Radiation Center

Reference: Oregon State University TRIGA Reactor, License No. R-106,  
Docket No. 50-243

RESPONSE TO  
NRC REQUEST FOR ADDITIONAL INFORMATION  
DATED JULY 20, 1979

OREGON STATE UNIVERSITY TRIGA REACTOR  
LICENSE NO. R-106  
DOCKET NO. 50-243  
AUGUST 17, 1979

Fig. 6 Typical Channel and Detector Operating Ranges

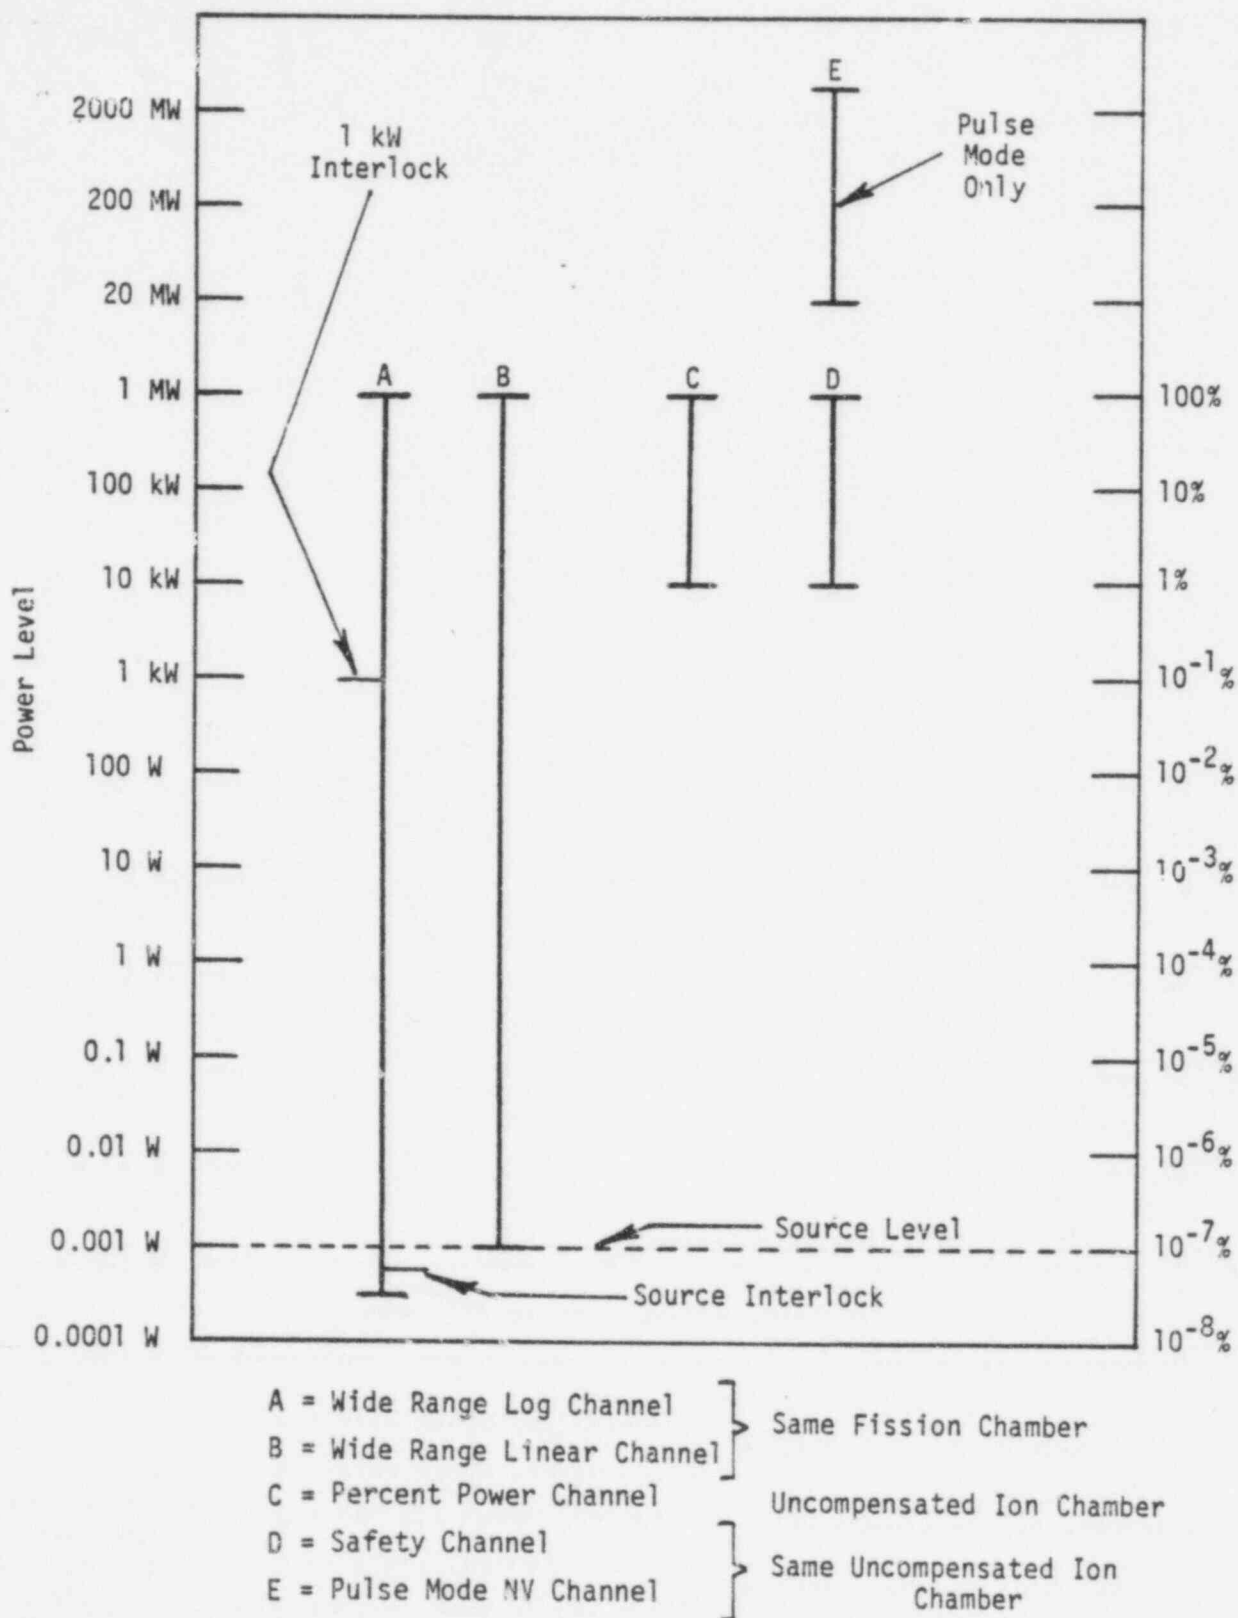
6. Figure 6 shows the operating ranges of the proposed instrumentation channels.
7. Our existing power supply arrangement consists of one high voltage supply unit and one low voltage supply unit for the four nuclear instrument channels.
